# QUIKTRIP 4283

## SITE PLAN

1st Review  
Aurora Water  
Jenny Wynn  
jwynn@auroragov.org

QUIKTRIP 4283  
E-470 & EAST 64TH AVENUE  
SITE PLAN  
COVERSHEET

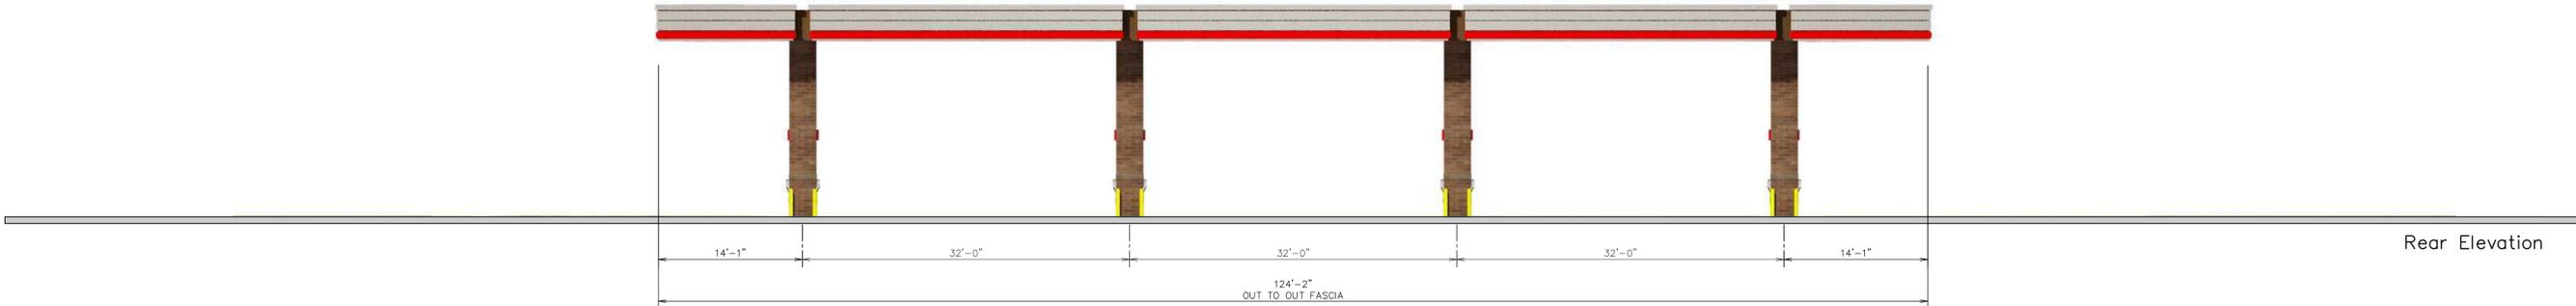
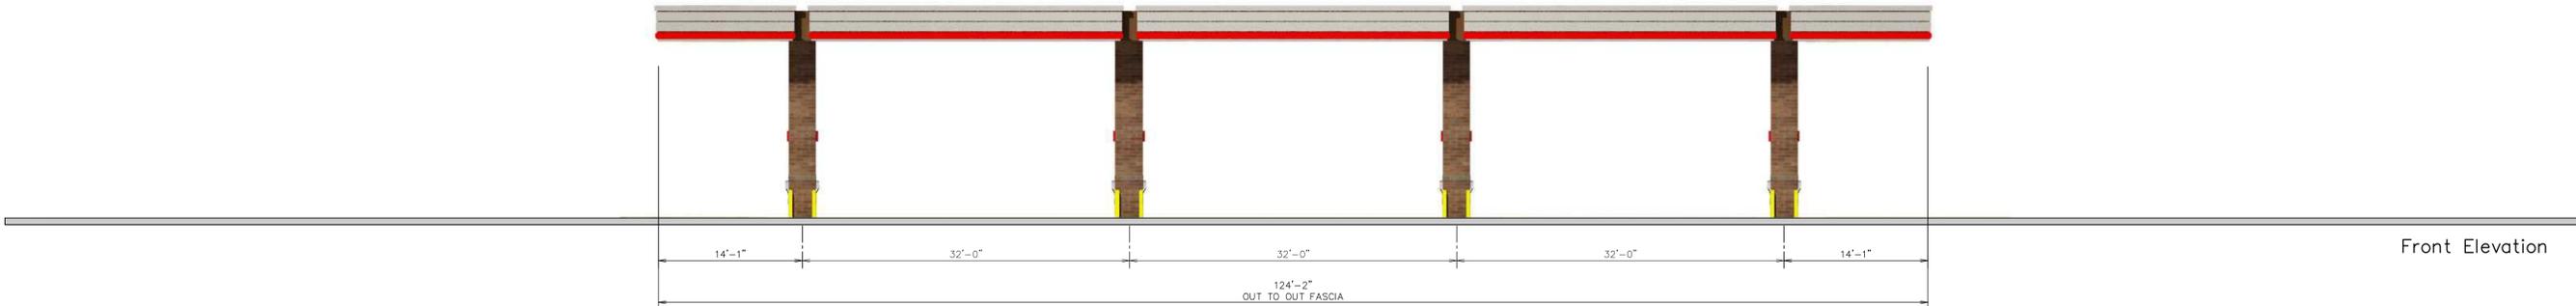
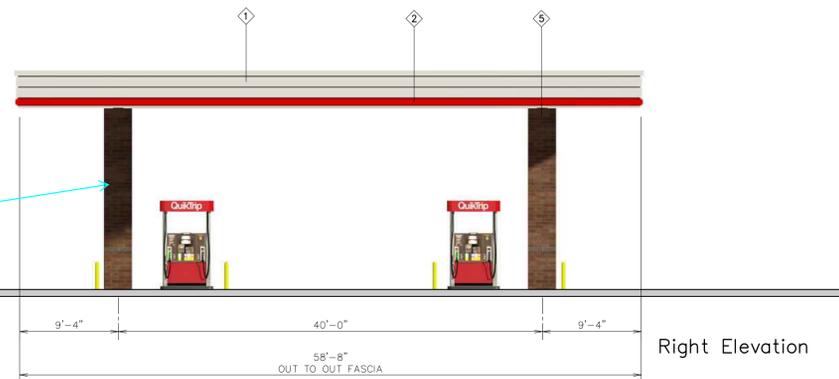
all signage areas shown may not be allowed, please show how these meet code

provide dimensions and detail of all canopy columns to meet UDP 3.3.5.00.9.c
